1984 Corvette: Service Bulletin: No Heat - A/C Control Unit

Source: Chevrolet Dealer Service Technical Bulletin

Bulletin Number: 83-T-70, Number Ia

Date: August, 1983

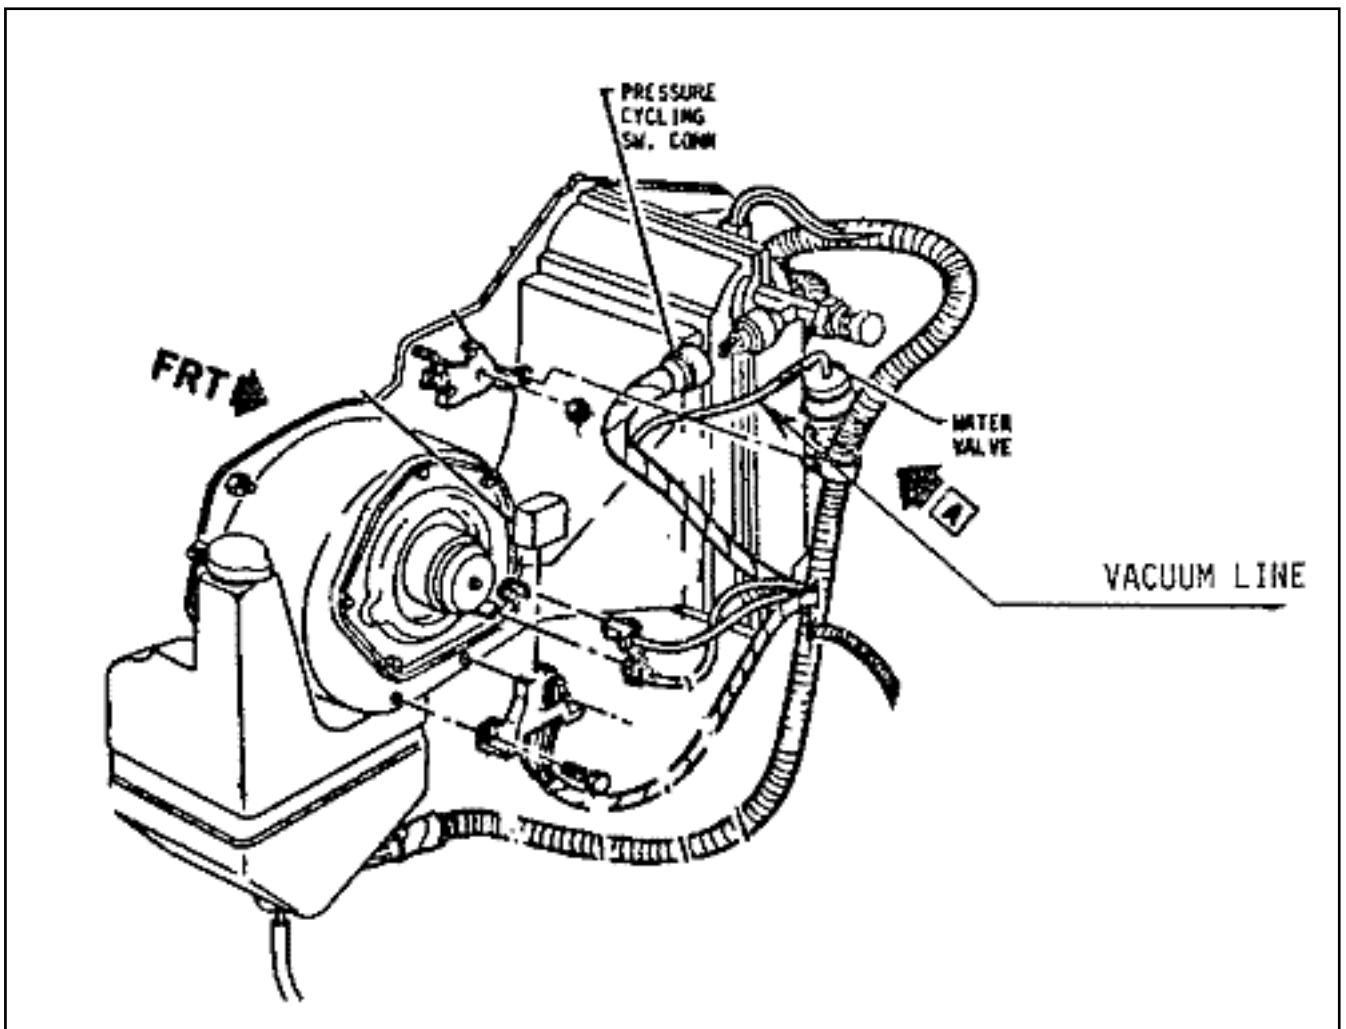
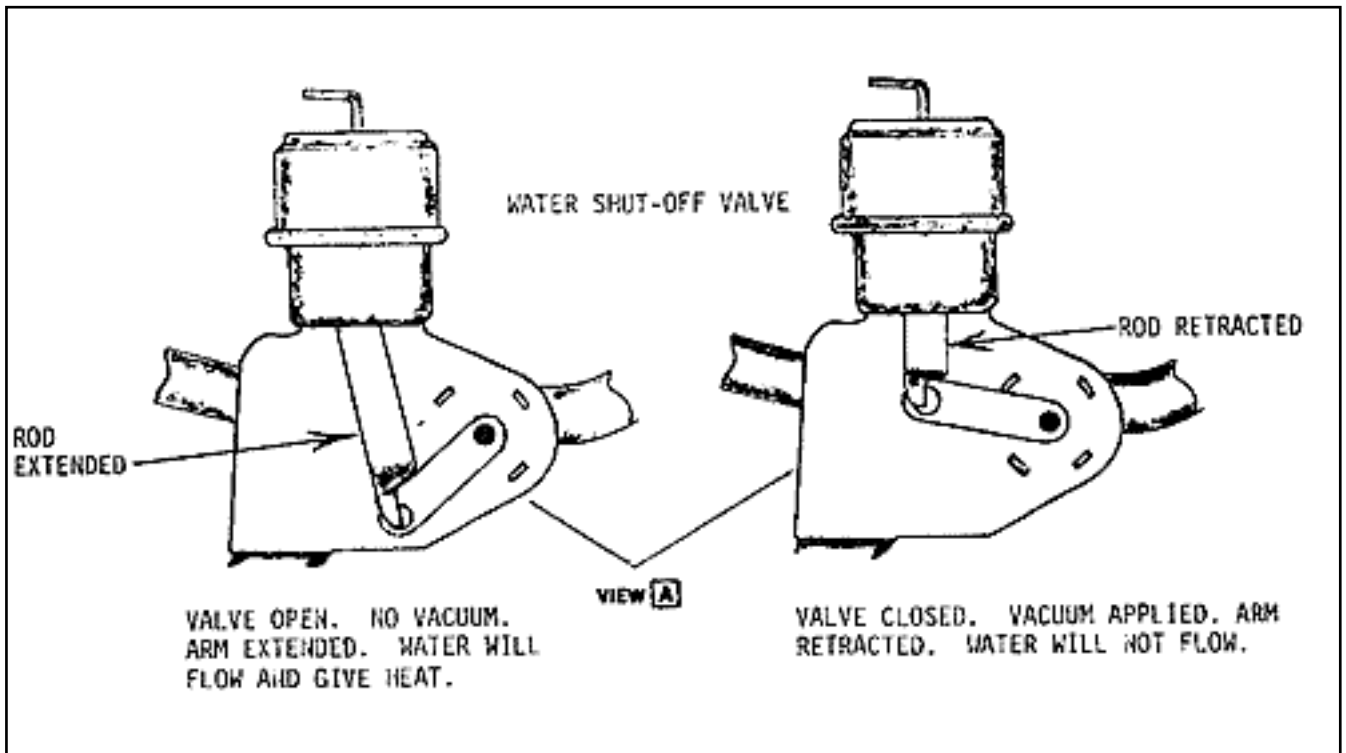
The vacuum switch in the A/C control unit controls a water shut off valve on the evaporator blower assembly. This valve should be closed with the temperature selector lever in the full cold position and open with the lever in any other position. Water will not flow through the heater core when the valve is closed (vacuum applied). Note that the valve actuating rod will be extended when the valve is open and retracted when closed (refer to sketch).

1. Observe the operation of the valve on the blower assembly while the temperature selector lever is moved from "cold" to "hot" position. The engine must be running to supply vacuum and should be at operating temperature.
2. If the valve opens (rod extended) when the temperature selector lever is moved to the "hot" position and heat output does not occur, the condition is not directly related to this particular control unit problem and should be further diagnosed, as described in Chevrolet Service Manual, Section 1.

3. If the valve does not open (rod retracted) remove the vacuum line from the valve. If this causes the valve to open and results in heat output, refer to Step 4.
4. Leave the vacuum line off the valve and seal off the end of the line to prevent a vacuum leak. (This can be done by fabricating a rubber plug or equivalent.) Secure the loose line to the harness with a band strap.
5. The vehicle can be operated with this line disconnected from the valve with no adverse effect to the A/C system.
